Kimimage to City Centre Core Bus Corridor Scheme

NTA Observations on the Proposed Scheme Section 51

June 2024

Figure 2-4-1: Construction Compound K2 at Our Lady’s Hospice

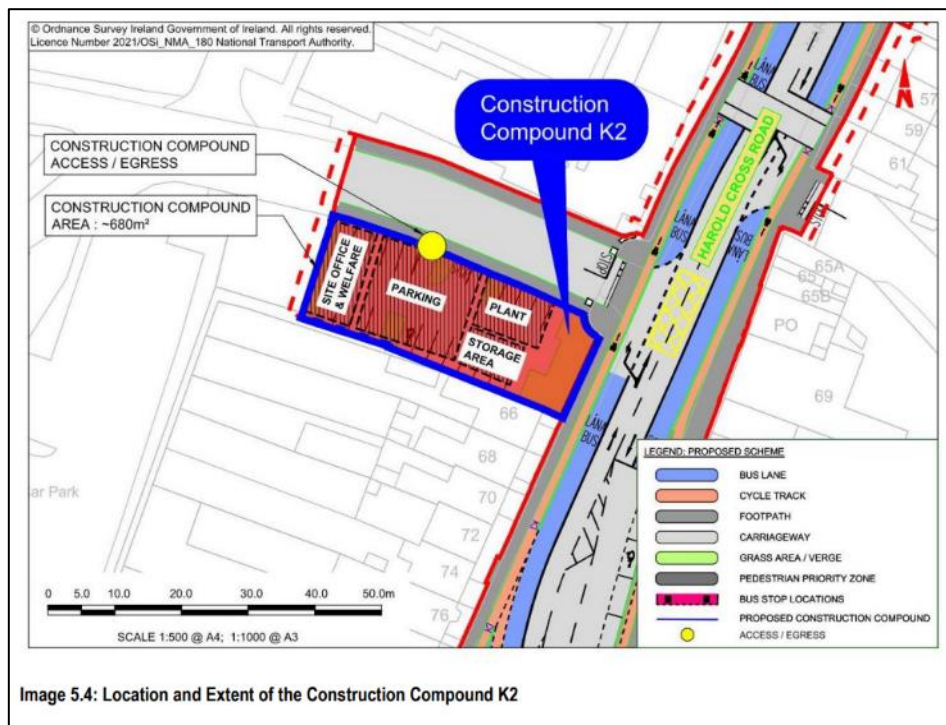
The proposed construction compound K2 will be located on the un-used grass lawn area along the southern side of the access road into the hospice as described in EIAR Volume 2, Chapter 5, Section 5.7. An indicative layout of the compound is shown in Image 5.4 in EIAR Chapter 5, and this is reproduced in Figure 2-4-1 below. The compound will not impede access to the hospice which will continue along the existing access road beside the proposed compound. In addition, Section 5.2.3.15 in the Construction Environmental Management Plan (Appendix A5.1 in Volume 4 of the EIAR) states: “.... Access will be maintained for emergency vehicles along the Proposed Scheme, throughout the Construction Phase”

EIAR Chapter 5, Section 5.7.2 sets out what will be contained in the Construction Compound:

Figure 2-5-4: Proposed Public Realm Improvements at Kimmage Village

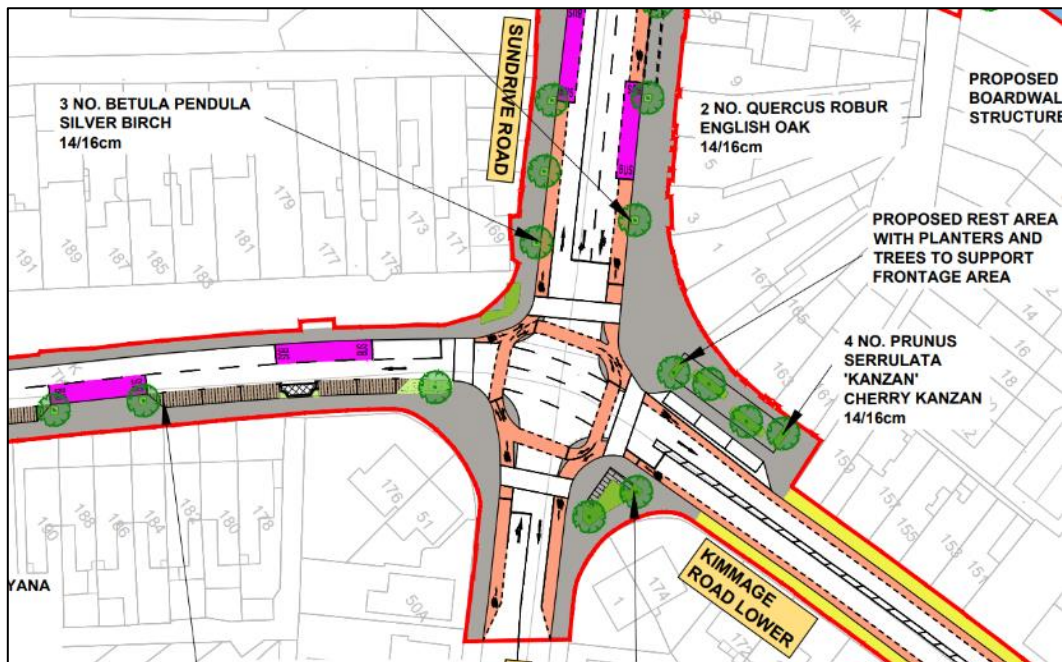
- 13) Support for public realm improvements / Comments on specific aspects of the proposals at Sundrive Cross. Curtailed public realm south of Sundrive Cross regretted by several submissions.

Generally the footpaths along the extents of the Proposed Scheme are not wide enough to accommodate much street furniture other than essential signs and lamp posts. Where there is more space such as at Kimmage Village, the Proposed Scheme will provide new street furniture to an appropriate degree. This is illustrated in Figure 2-5-4 (from EIAR Volume 3 Figures, Part 5, Sheet 3) which shows a proposed rest area with planters on the northwest corner of the junction at Sundrive

Road which is a sunny spot with a generously wide footpath area. The existing layout at this location was recently modified by Dublin City Council to extend the footpath with the removal of a small parking area. NTA understands that this parking is of particular use for customers of Thom's Pharmacy a short distance to the north, which is why it was shown to be retained in the Proposed Scheme.

Figure 2-9-6: Proposed Scheme Layout at Clanbrassil Street Lower (Sheet 09)

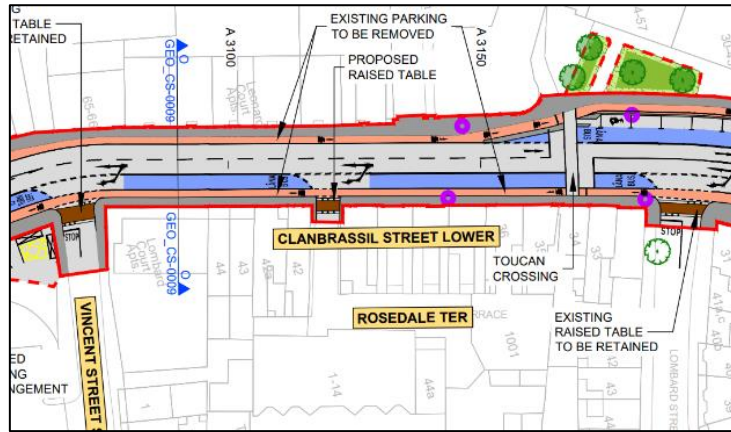
1. *“The provision of footpaths designed to the minimum width may not be sufficient in areas of high pedestrian traffic, particularly in urban villages and busy commercial streets, e.g. the footpath on Clanbrassil Street Lower (Sheet 09) and Harold’s Cross Road (Sheet 07).”*
2. *“The removal of the footpath on Harold’s Cross Road at the northern side of the park (Sheet 06) is generally not supported. If it is not possible to retain the footpath, it is suggested that the design of the junction of Harold’s Cross Road and Kimmage Road Lower could be reviewed to provide a new pedestrian crossing running north-south on Kimmage Road Lower and into a proposed new entrance into the park.”*
3. *“Footpath widths also need to account for congregations of passengers waiting in the vicinity of bus stops.”*

of the street between Vincent Street South and Lombard Street West with existing footpaths that are only 1.8m wide in places. This section of street is very constrained, and the footpaths could not be widened. In the proposed scheme the northbound bus lane has been omitted along this section as can be seen in Figure 2-9-6. The cycle tracks will be reduced to 1.5m wide through this narrow section of street so as to fit in the limited space available between the existing kerbs, which will be retained. On this section of the Proposed Scheme all of the cross-section elements are at the minimum widths provided for under the relevant design standards, which is necessary due to the narrow width of the street.

Figure 2-9-7: Snapshot from General Arrangement Drawing Sheet No.6

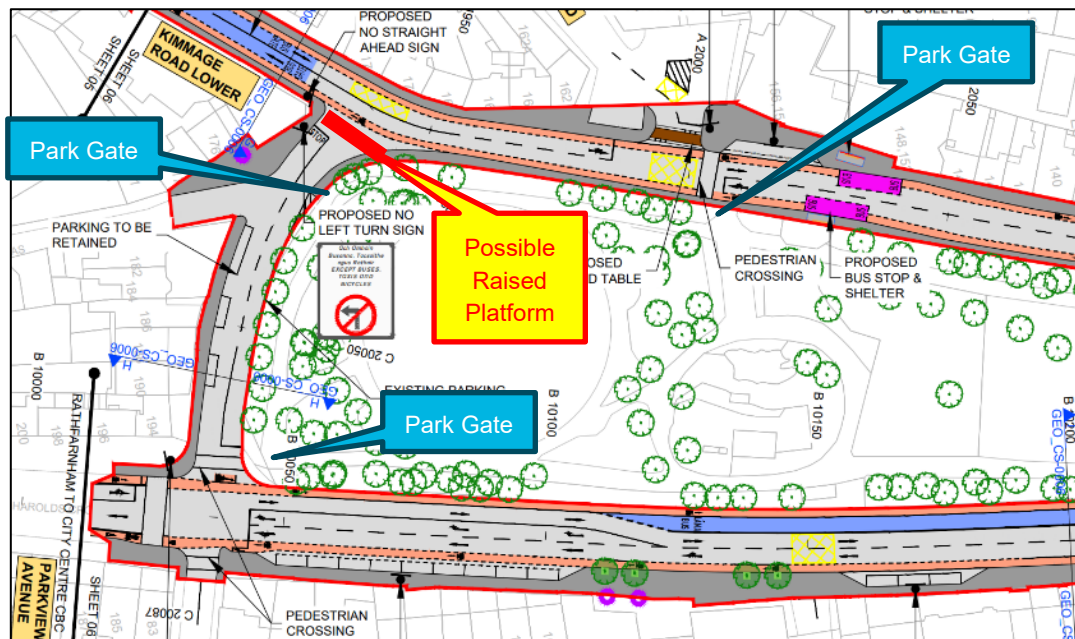
Point No.2 in respect of footpaths appears to refer to the short link street at the southern end of Harold’s Cross Park (not the northern end of the park) between Kimmage Road Lower and Harold’s Cross Road as shown in Figure 2-9-7. In the Proposed Scheme this short link street will be widened on the northern side to accommodate two-way traffic properly, alongside the retention of existing on-street parking for the houses on the southern side. The widening will require removal of the existing footpath along the northern side of the road adjacent to the park. The alternative option of removing the existing parking on the southern side of the street would adversely affect the amenity of the residents of the period houses, most of which do not have driveways for off-street parking, in a context where there is a general severe lack of alternative parking available in the area.

This section of street carries a very small flow of traffic at present, but that will increase slightly due to the proposed bus gate on Kimmage Road Lower at the northern end of the park, which will divert local access traffic around the southern end of the park towards Mount Jerome Cemetery, Mount Argus Road and homes opposite the western side of the park. There are three existing gates into the park as shown on Figure 2-9-7, including one at the southwestern corner. NTA accepts the suggestion by DCC Architect’s Division that an improved pedestrian crossing could be provided at the junction at the western end of the link street where it joins Kimmage Road Lower, and this is indicated as a red line for a raised platform which would operate as a “courtesy crossing” as described in the *Design Manual for Urban Roads and Streets (DMURS)*.

Figure 2-10-1: Junction of Kimmage Road Lower and Ravensdale Park

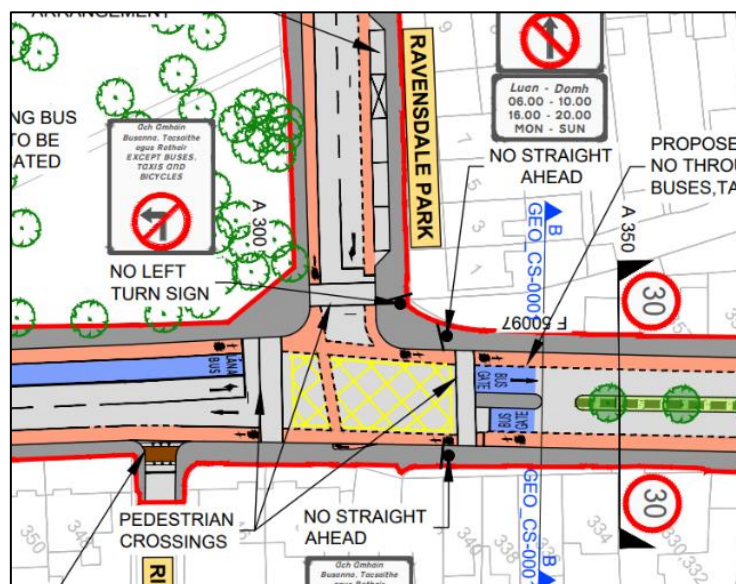
The submission states that the provisions for cyclists at three particular junctions do not fully comply with the Cycle Design Manual with insufficient segregation for cyclists at Ravensdale, Mount Argus View and Harold’s Cross Road / Kimmage Road Lower. The Proposed Scheme design at these three junctions is shown in Figures 2-10-1, 2-10-2 and 2-10-3, followed by a discussion about the provisions for cyclists.

The junction at Ravensdale Park is unusual in that it is located at proposed Bus Gate No.1 just to the north. Northbound cyclists and buses will be separated from general traffic in the signal staging and will not move concurrently. General traffic will be required to turn left at this junction when the bus gate is operational. Buses and cyclists will move in the preceding signal stage while general traffic is held. There is no requirement therefore to provide a protective traffic island on the southwest corner of this junction for separation of left-turn traffic from cyclists. Such an arrangement is not covered by the generic junction layouts shown in the *Cycle Design Manual*, but the junction design is compliant with the general principles of the design manual.

Figure 3-1: General Arrangements Drawing Sheet No.6 at Harold's Cross Park South

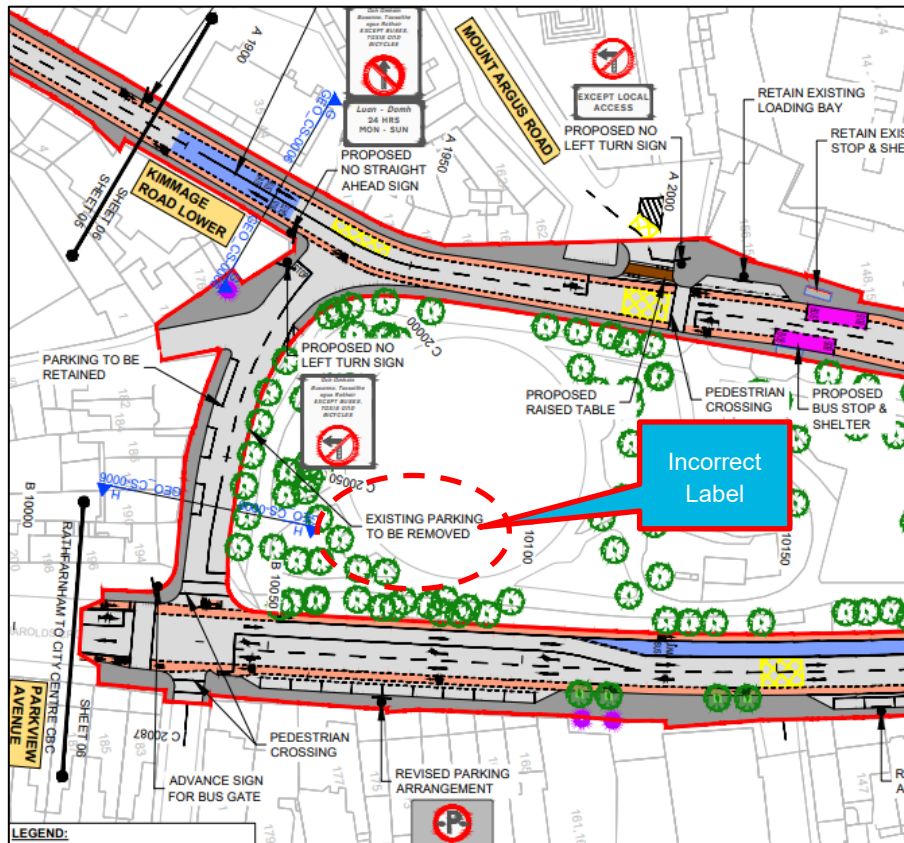
For Issue No.3 this submission says that there is an incorrect label on General Arrangement Drawing Sheet No.6 which points to "Existing parking to be removed" on the northern side of the short link street at the southern end of Harold's Cross Park. That label should say "Existing footpath to be removed". This error is corrected in this response.
